**ASHLAND PLANNING DEPARTMENT SITE:
PRE-APPLICATION CONFERENCE
COMMENT SHEET**

79 Lincoln Street

APPLICANT: Chris Brown, Arkitek for Ashland School District

REQUEST: Residential Site Design Review, Exception to Street Standards

N. Mountain Avenue Future Improvements
Section A – Looking North

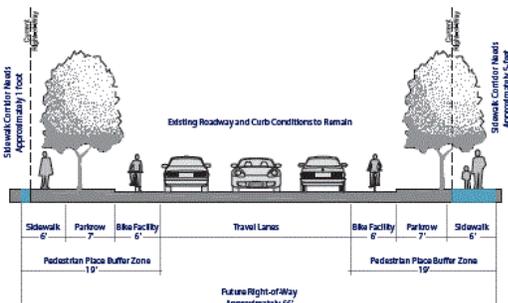
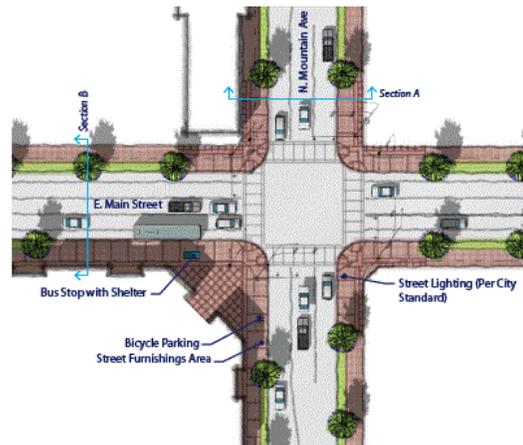
[18.3.12.060](#). The city standard improvement for East Main Street as detailed in the [Pedestrian Places Overlay](#) is 66 feet of right of way with 19 feet of pedestrian buffer zone and 28 feet for automobile travel lanes as described in [AMC 18.3.12.060](#), and generally illustrated in the cross-sections below:

Staff would note that the right-of-way width and street improvements along East Main Street and North Mountain Avenue are less than the minimum required for the street type, are not to city street standards, and are steeply sloped with retaining in place which would complicate city standard frontage improvements and design/orientation of the street frontage units. Placing required improvements outside of the existing right-of-way would require either dedication of public right-of-way or access easements and would need to be supported by the Public Works/Engineering Department. *Should the applicant determine that an Exception to Street Standards is necessary to address the existing grades, staff are open to this discussion.* [Street design should also consider local street light standards and the placement of street lights and associated electrical infrastructure, and should consider existing utility infrastructure in place in and near the right-of-way, particularly at the corner of Mountain & East Main.]
